OMRON

Product Discontinuation Notices

No.2009191E

Discontinuation Notice of Motor Timer: H2C

Dimensions

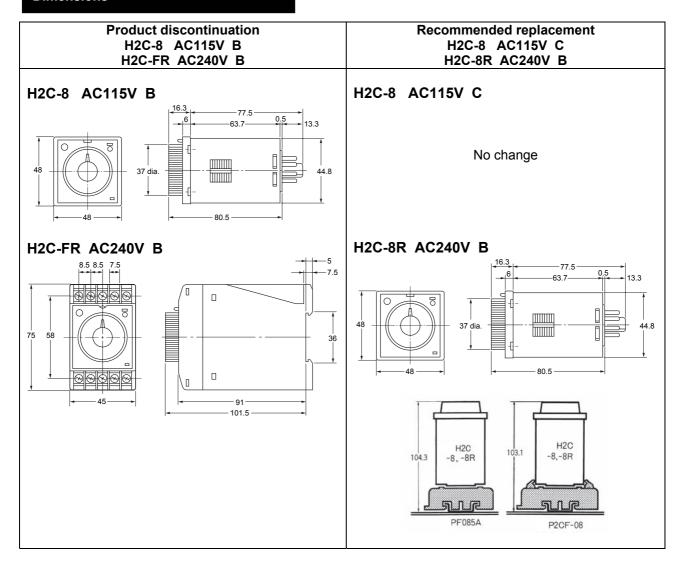
Time range will be different.

Externals change to the Octal pin type.

| Product discontinuation H2C-8 AC115V B | Recommended replacement H2C-8 AC115V C | | |
|--|---|--|--|
| Time range: 6s, 60s, 6m, 60m, 6h (Maximum scale time) | Time range: 12s, 120s, 12m, 120m, 12h (Maximum scale time) | | |
